**ADDENDUM NO.:** One

**PROJECT TITLE:** Pavement Rehabilitation Project at Newberry Middle and Newberry High School  
School District of Newberry County  
3419 Main Street  
Newberry SC 29108

This Addendum is issued for the purpose of revising plans and specifications which have been previously issued.

SKETCH NO:  
 SK-1

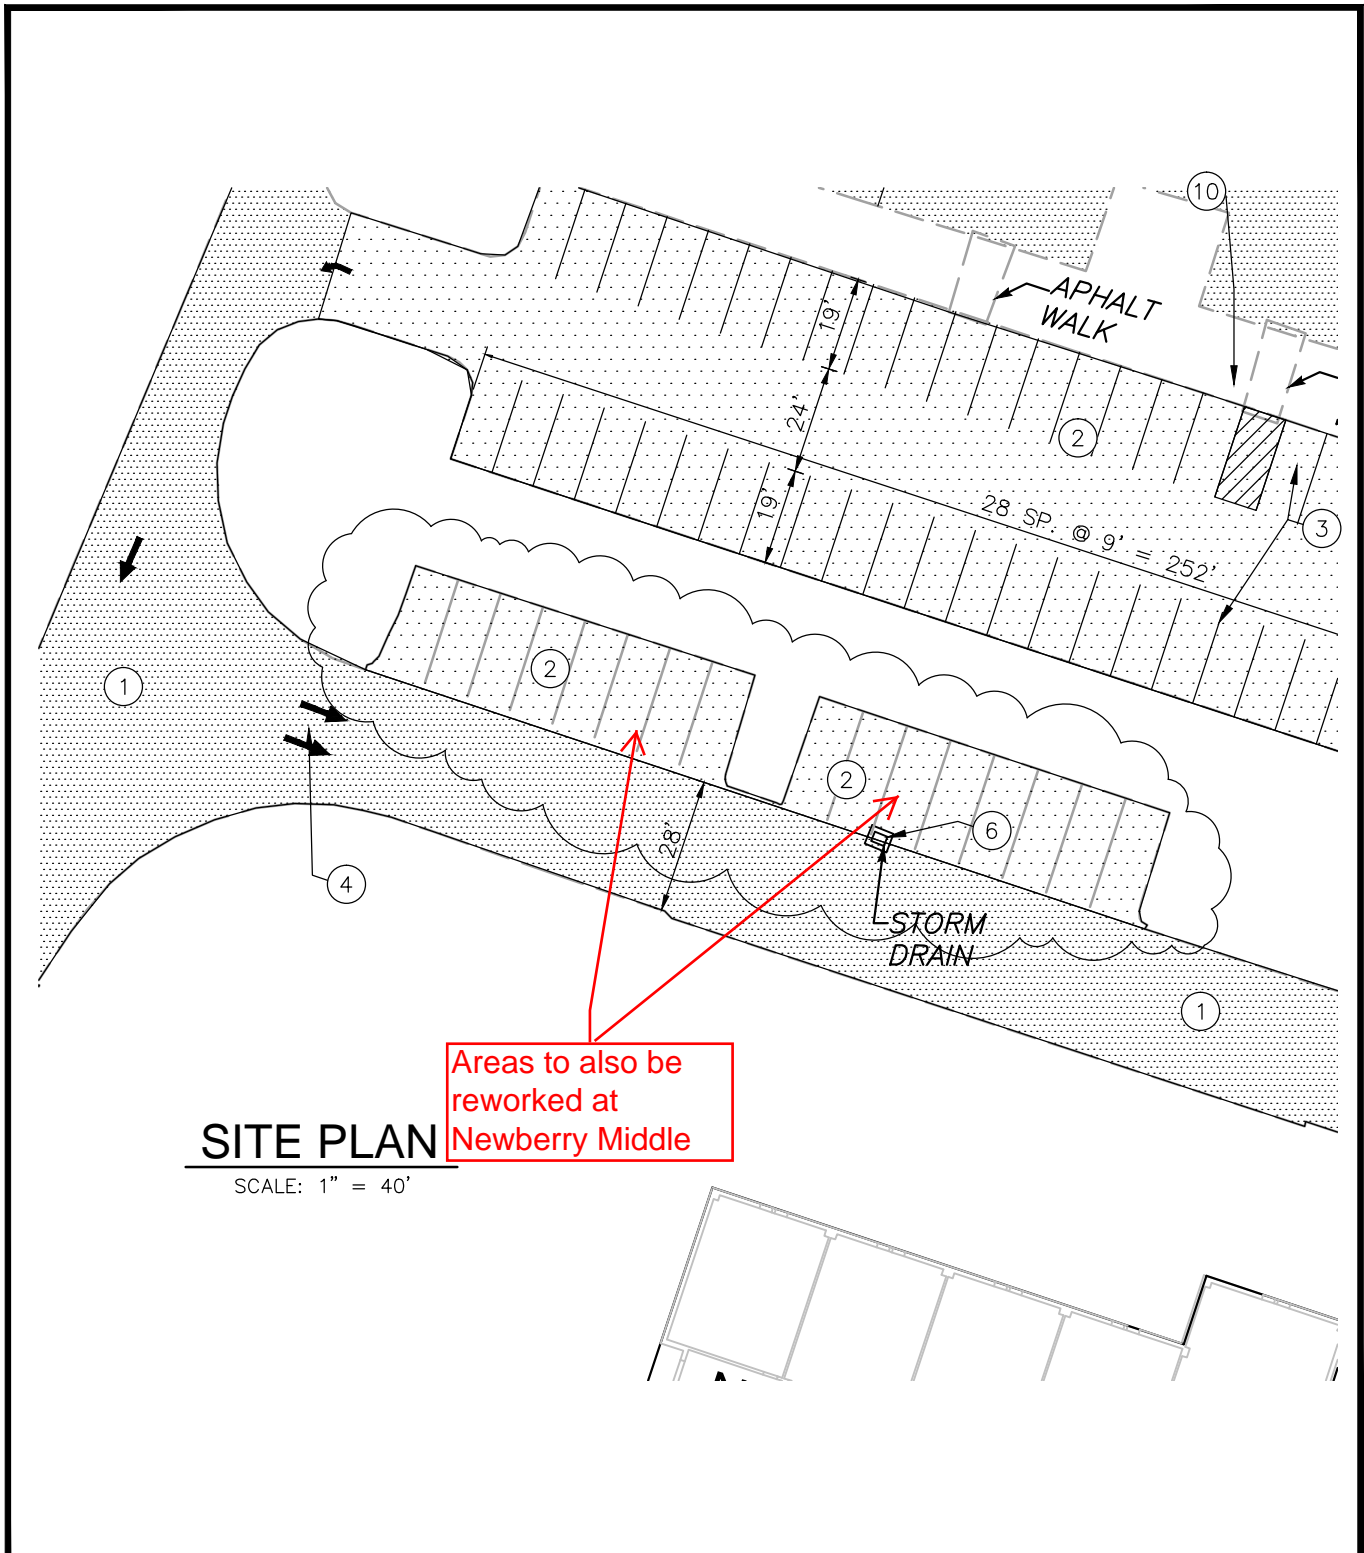
5.	Clarification on work scope at Newberry Middle School – see attached sketch SK-C1 for additional asphalt parking areas to be included in both Task 1 and Task 2 as light duty pavement areas.

Areas to also be reworked at Newberry Middle
